WELL API NO. 30-025-12358
5. Indicate Type of Lease STATE <input checked="" type="checkbox"/> FEE <input type="checkbox"/>
6. State Oil & Gas Lease No.
7. Lease Name or Unit Agreement Name WEST DOLLARHIDE DEVONIAN UNIT
8. Well Number 113
9. OGRID Number 16696
10. Pool name or Wildcat DOLLARHIDE; DEVONIAN

SUNDRY NOTICES AND REPORTS ON WELLS (DO NOT USE THIS FORM FOR PROPOSALS TO DRILL OR TO DEEPEN OR PLUG BACK TO A DIFFERENT RESERVOIR. USE "APPLICATION FOR PERMIT" (FORM C-101) FOR SUCH PROPOSALS.)	
1. Type of Well: Oil Well <input checked="" type="checkbox"/> Gas Well <input type="checkbox"/> Other <input type="checkbox"/>	
2. Name of Operator OXY USA INC. (16696)	
3. Address of Operator PO BOX 4294, HOUSTON, TX 77210	
4. Well Location Unit Letter <u>C</u> : <u>667</u> feet from the <u>NORTH</u> line and <u>1859</u> feet from the <u>WEST</u> line Section _____ Township _____ Range _____ NMPM _____ County _____	
11. Elevation (Show whether DR, RKB, RT, GR, etc.)

West Dollarhide Unit 113

Proposed PA Procedure

CURRENT WELLBORE

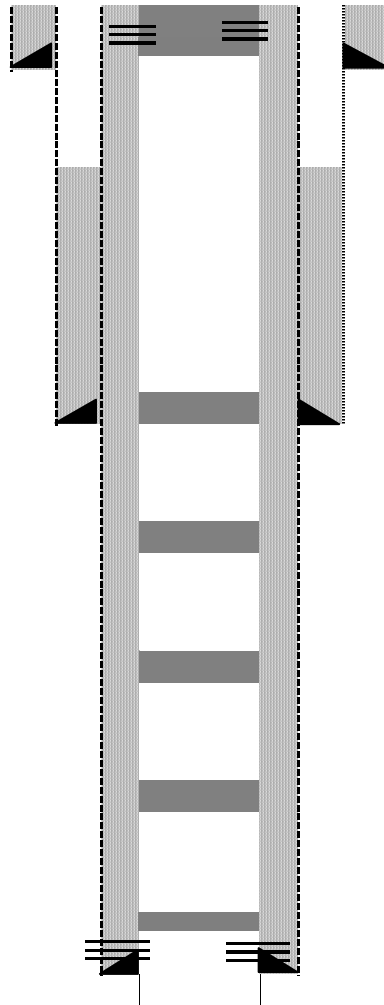
SEE CHANGES TO PROCEDURE

Run CBL to surface.

1b. Spot 40 sx cmt @ 7360' 7260' - T. of Wolfcamp

1b. spot 40 sx cmt - 6667' - 6567' - T. of Abo

Set Plug from ~~5250'~~

Spot from 5272'

Set Plug from ~~4100'~~

Spot from 4139'
